**ADDENDUM #2**  
INVITATION FOR BID #24-65

**NEWTON COMMONWEALTH GOLF COURSE MAINTENANCE FACILITY  
IMPROVEMENTS AND RENOVATIONS**

Addendum to the Bidding Documents  
**Newton Commonwealth Golf Course**  
**Maintenance Facility Improvements & Renovations**

Addendum No. 2  
April 22, 2024

**PIPING AND CONTROL SCHEDULE**

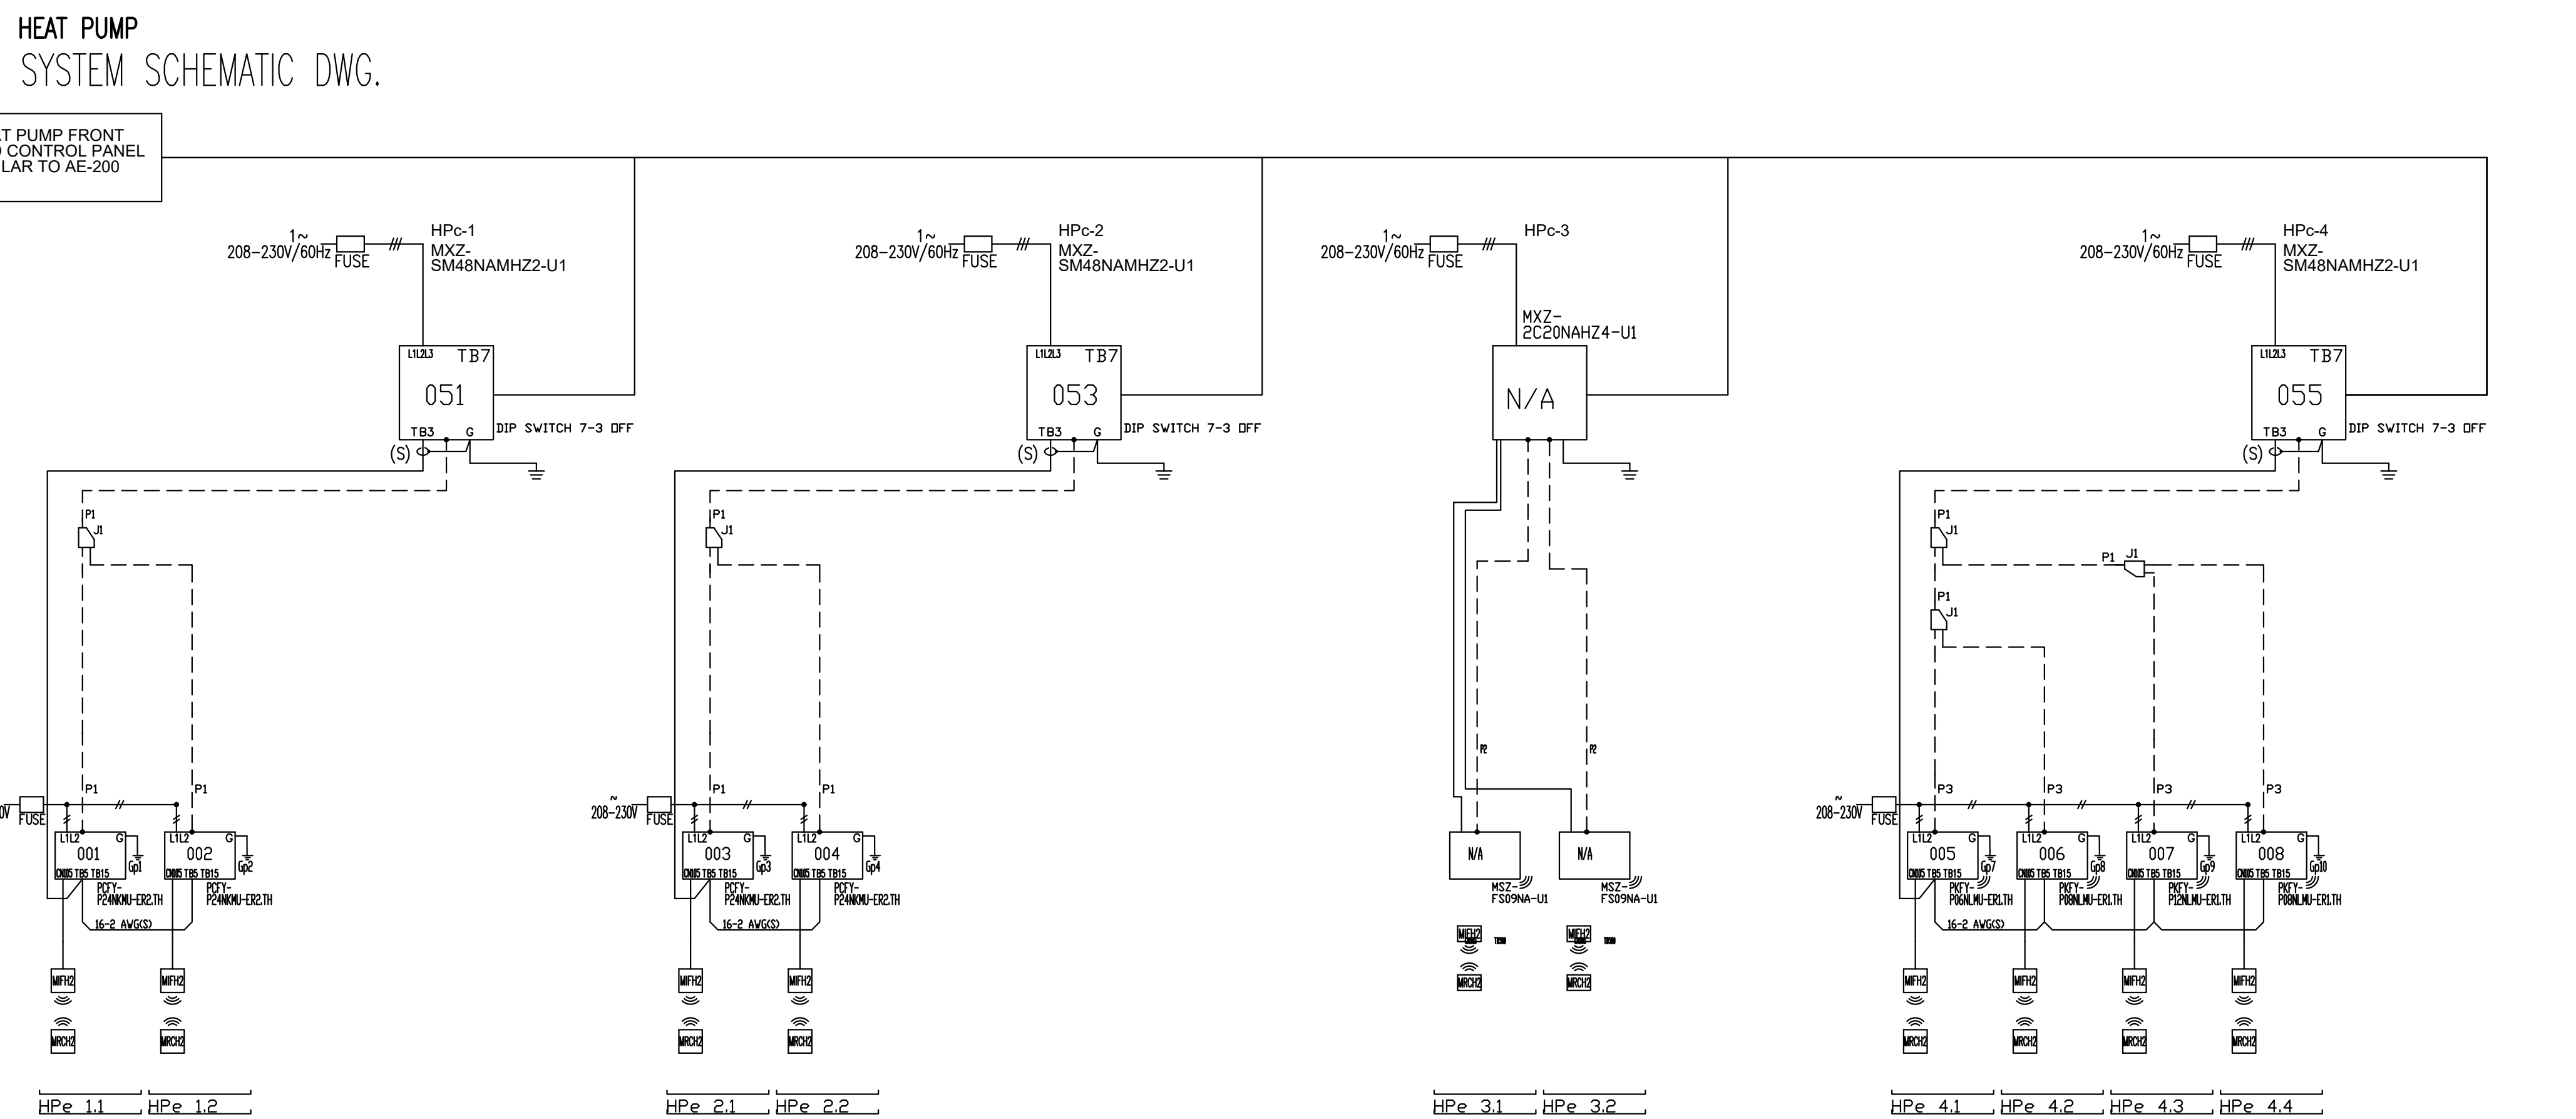
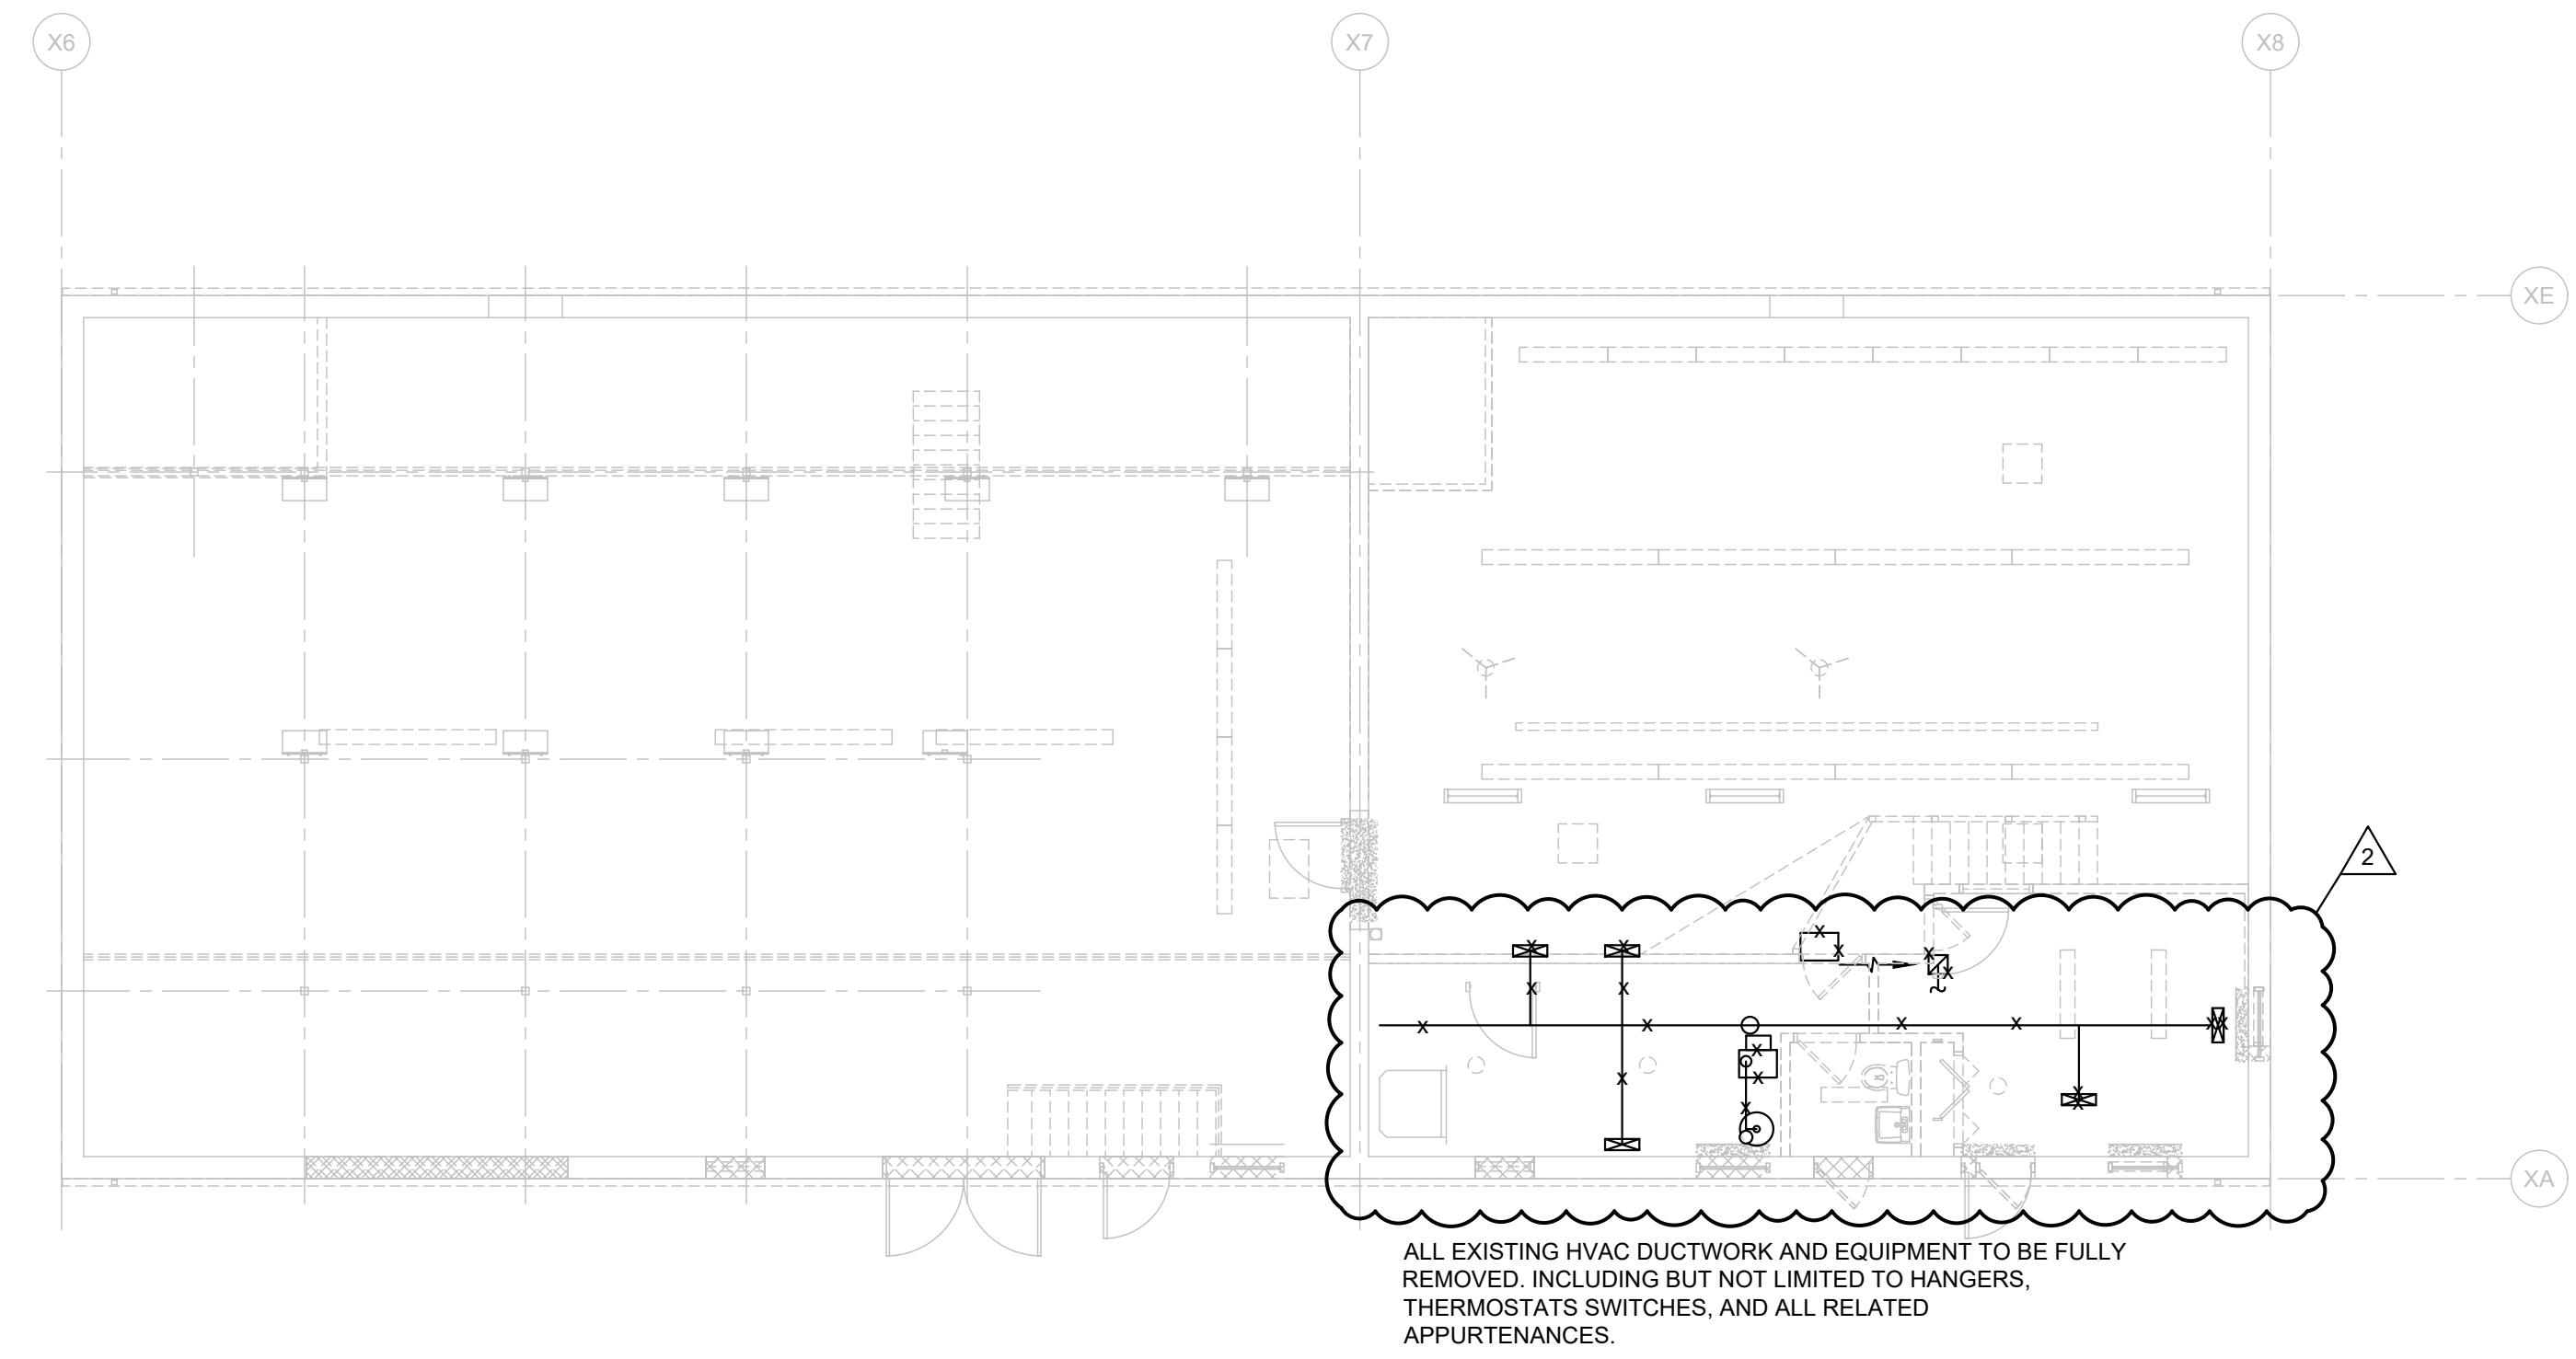
**Q1. Please Provide a VRF System Refrigerant Piping Schematic For HPc-1, HPc-2, HPc-3, and HPc-4**

**Q2. Heat Pump Schedule Note on Plan M0.0 States to provide Branch Boxes however none are shown or scheduled. Please revise this note, or provide a schedule and show in plan-view the Branch Boxes.**

**Q15. Plan M0.0 Heat Pump Schedule appears to have several issues that prevent Mitsubishi from quoting this project. HPC-1 is ok. HPC-2 (4 Ton unit) is too small to have Two (3 Ton Units) on it. HPC-3 has two small residential style wall heads (1 Ton each) with a 3 Ton outdoor unit where the Model doesn't match the btu's on heating/cooling. HPC-4 has a mix of residential units and city multi units which will not work. Please revise the schedule so the basis of design manufacturer can quote the project.**

**A1. REFER TO UPDATED M0.0 PLAN WITH HP SCHEMATIC.**

**A2. BRANCH BOXES NOT REQUIRED. REFER TO UPDATED HP SCHEDULE AND PIPING SCHEMATIC.**

**A15. REFER TO UPDATED HEAT PUMP SCHEDULE AND SCHEMATIC ON M0.0.**
